UNITED STATES PATENT AND TRADEMARK OFFICE

APPLICATION NO.	FILING DATE	FIRST NAMED INVENTOR	ATTORNEY DOCKET NO.	CONFIRMATION NO.
10/032,454	01/02/2002	Ulrich Watermann	12383-04/ejg	6577

Office Action Summary

DETAILED ACTION

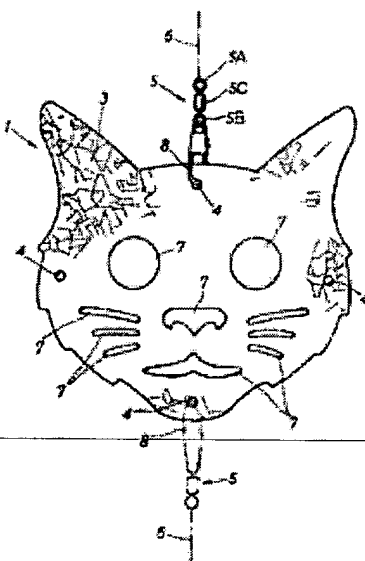
In regards to **claim 3**, Takeda fails to teach an apparatus including a central post for suspending and rotatably moving the silhouette (1). However, Kilgore discloses an apparatus including a central post (16L, 16M, 16U) with extending arms (14B) at the top thereof. The arms (14B) include wind moveable vanes to rotatably propel the arms about the post (16L, 16M, 16U) with another end of the line (14CL, 14CR) hanging from the arm (14B) so as to rotatably move the silhouette (1) about the post (16L, 16M, 16U). See Figure 2 below. Therefore, it would have been obvious to one having ordinary skill in the art at the time of the invention to modify the scaring device disclosed by Takeda, as modified, to include the mounting device, shown by Kilgore, in order to provide a means of moving the scaring device to spook unwanted birds.

In regards to **claim 4**, Takeda, as modified in the previous claim, teaches a device wherein each of the arms (14B) includes a hanging device. See Figure above.

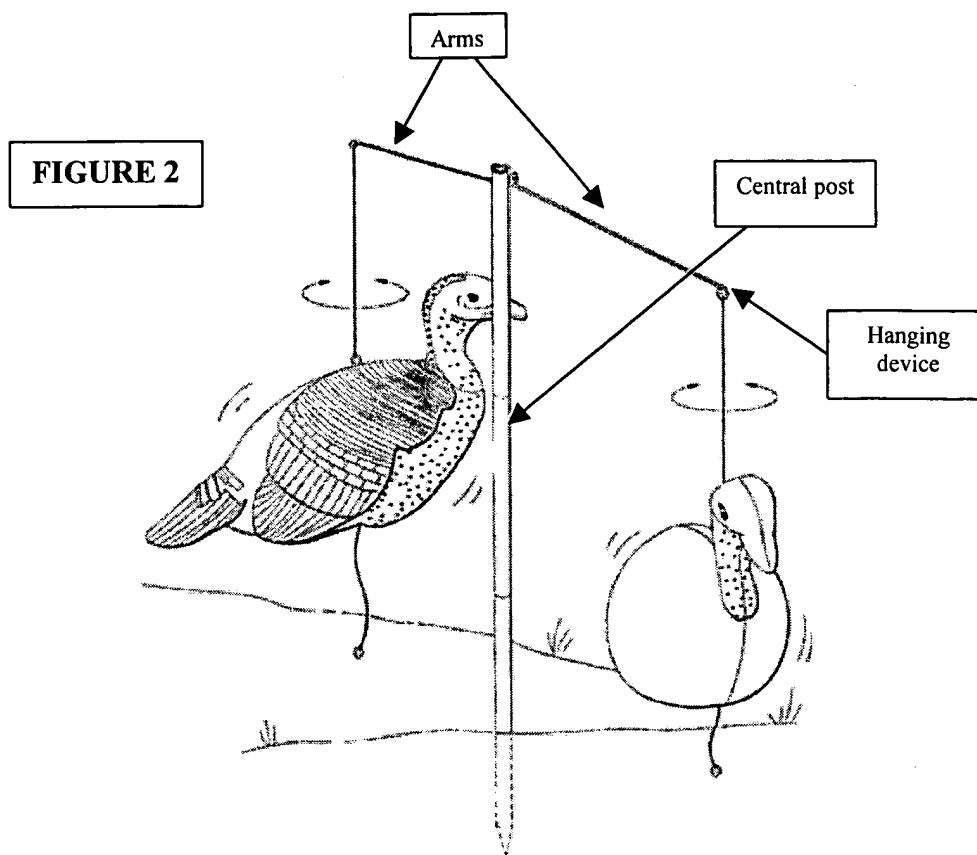
Regarding **claim 2**, Takeda as modified, teaches a device further including a swivel (5C) connected to the hole (4). One end of the line (6) is connected to the swivel (5C) so as to permit the silhouette (1) to rotate relative to the line (6). See Figure 1 above.

In regards to **claim 8**, Takeda as modified teaches a device wherein the panel freely rotates about the first and second lines (6). See Figure 1 above.
